PLANNING DEPARTMENT
Staff Report & Recommendation

Design Review Board

SUBJECT: DRB18-0337
1600-1634 Alton Road "1212 Lincoln Road"

MODIFIED SIZE OF GRAPHIC ON SOUTHERN WALL

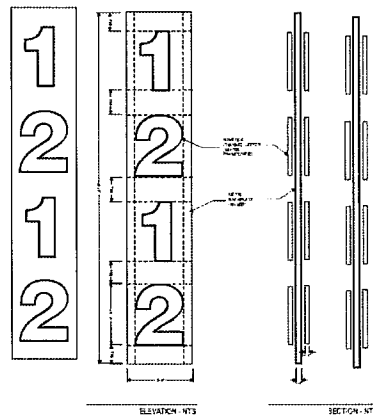
The applicant is requesting approval for a revised "electronic noncommercial graphics and images" (artistic super graphic). Pursuant to a settlement agreement between the City and the Applicant, for a reduction in size for the south wall graphic from 3,380 SF to no greater than 1,005 SF in area. Additionally, a reduction of the operational hours for both signs was agreed upon as part of the settlement agreement. The final location, orientation, and placement of the LED on the south wall is still pending final decision by the applicant, as such a flexible location has been proposed (P. 38 of submitted plans). Staff is supportive of the reduced size and recommends that the applicant incorporate a scored patterning in the stucco to provide some visual interest to the otherwise blank wall resulting in the reduced screen size.

PARKING SCREEN

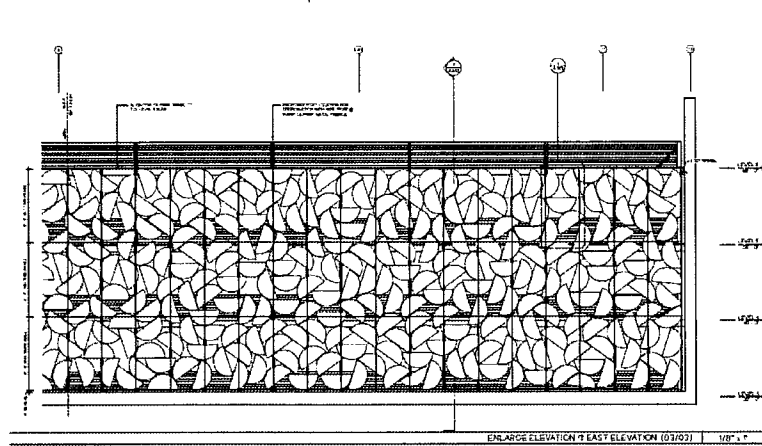
Along the Alton Road elevation from levels 3 to 5, the applicant is proposing to conceal the parking levels with a 287'-3' wide by 29'-0" high metal screen. The screen is comprised of many perforated panels, each 4'-6" wide by 9'-8" high, that, with a pattern of openings averaging 36%, create images of circular segments with varying orientations. Each panel has a distinct pattern that is book matched, lending to an overall random design where the distinction of panels disappears, and the circular slices are showcased. Details concerning the finish, texture and color of the metal panels have not been provided – essential details that can affect the design of the screen. In addition to material details, staff has concerns that the half-moon forms of the screening elements will not sufficiently conceal the parking levels from the right-of-way -which may be the intent of the design, but could prove to be a visual nuisance and diminish the architecture of the project.

While the project is across from the multi-story Regal Cinema and parking garage building across Alton Road and the potential for noise and light spillage stemming from vehicles and headlights is minimal, staff still would recommend opacity. Furthermore, the final finish and color details have not been provided for the screen. Additionally, the submittal does not provide details for the proposed screening along the rear of the property, abutting the alley and the neighboring multifamily district.

EXTERIOR LIGHTING (16th Street)

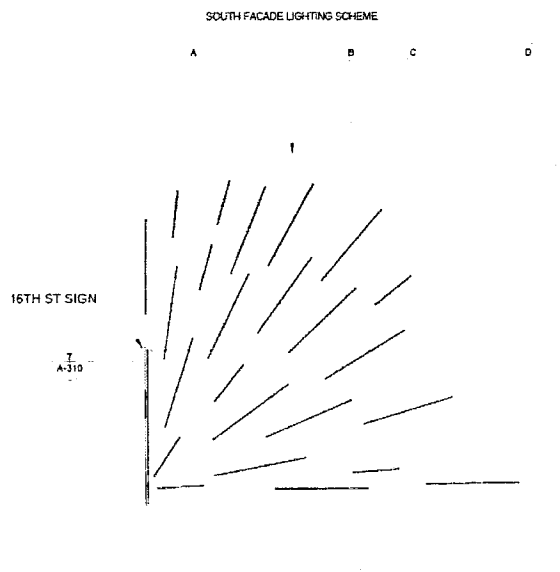
The applicant is proposing on the 16th Street façade a decorative lighting scheme. The proposed lighting is composed of different sized neon light tubes that spring from the dynamic *P A R K I N G* sign as rays – providing illumination on the entirety of the façade from the second floor up.

The light scheme is attractive, but staff has concerns with the height of the scheme and the potential for light spillage to neighboring residential buildings. As proposed, the upper levels of the southwest portion of the garage structure, 24 individual tubes of neon or LED lighting elements adorn in a radiating manner beginning from the "P" and terminating at the "G" of the 16th Street *P A R K I N G* sign. While this move integrates the architectural lighting of the building and highlights the proposed signage, the potential for light spillage and visual nuisance

- c. The proposed neon/LED lighting tubes along the upper levels of the southwest portion of the garage structure shall not be approved as proposed.
- d. A copy of all pages of the recorded Final Order shall be scanned into the plans submitted for building permit, and shall be located immediately after the front cover page of the permit plans.
- e. Prior to the issuance of a Certificate of Occupancy, the project Architect shall verify, in writing, that the subject project has been constructed in accordance with the plans approved by the Planning Department for Building Permit.
